Yuba Community College District

New Softball Field

ADDENDUM NO. 1

Thursday, June 29, 2023

6 GATE VALVE IN CONCRETE DETAIL

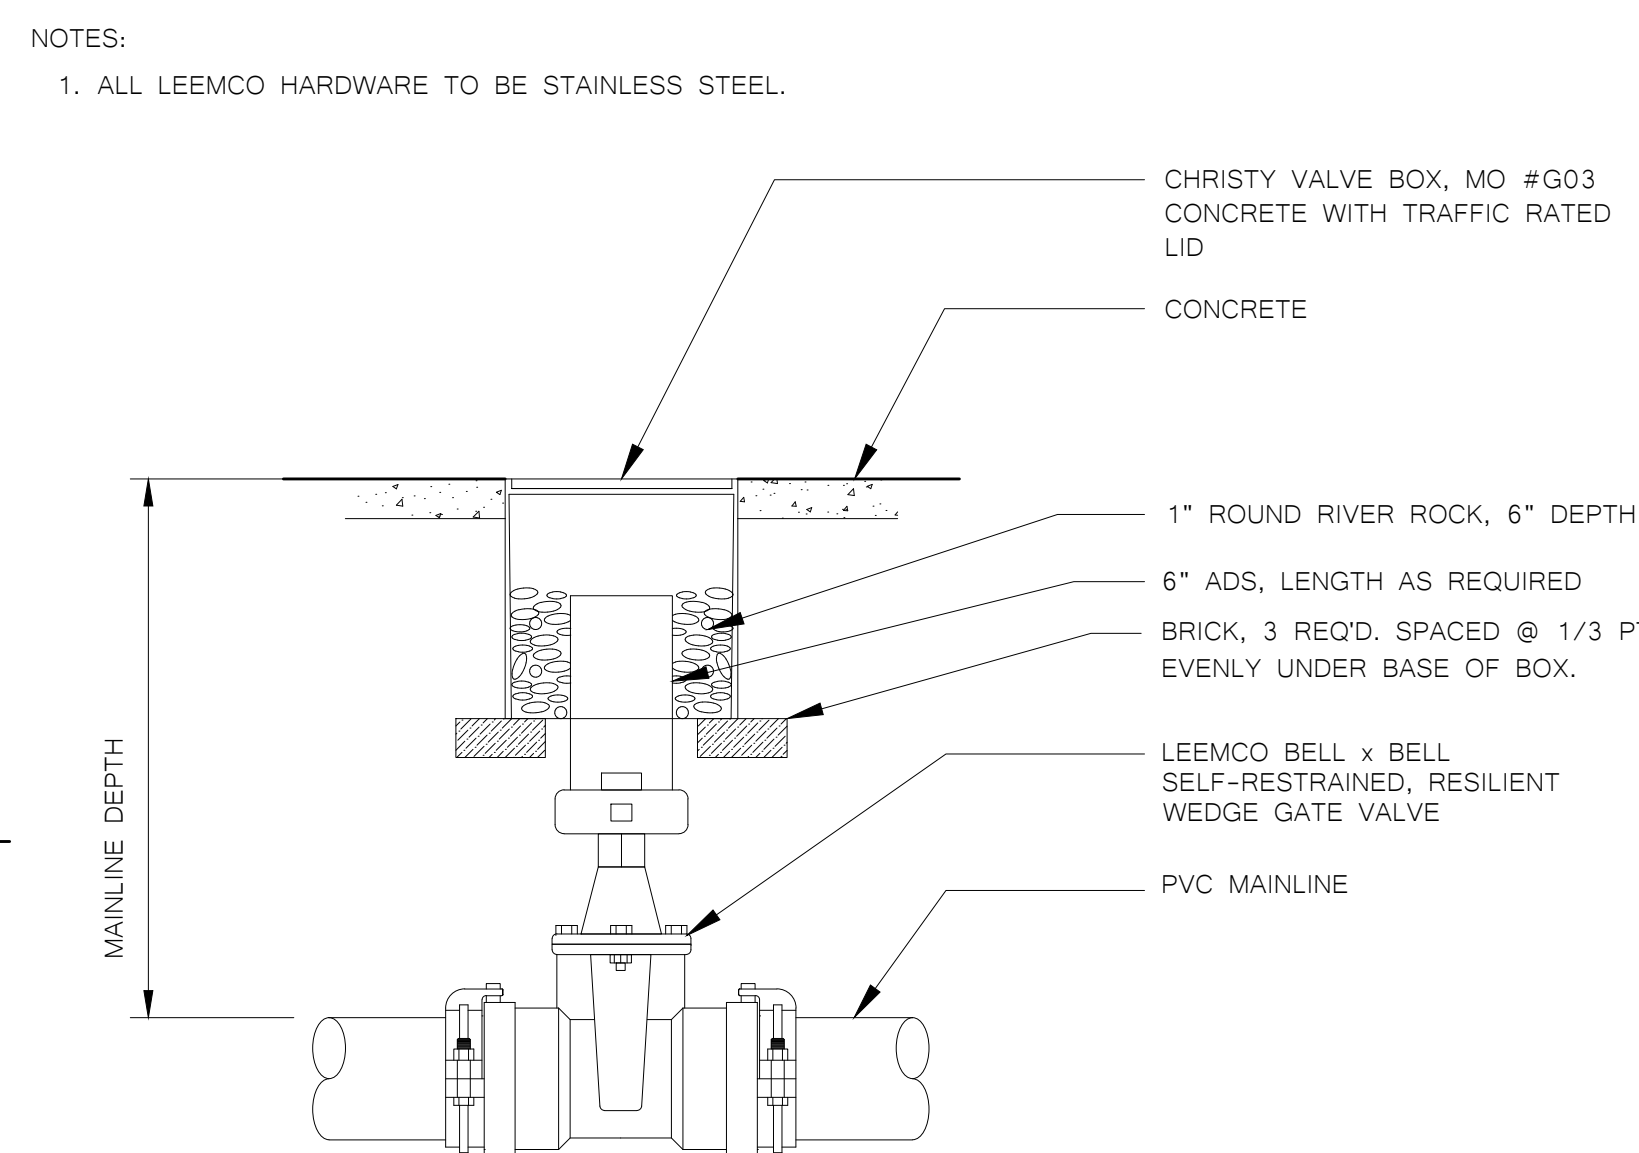
- A. **REVISE** gate valve detail.
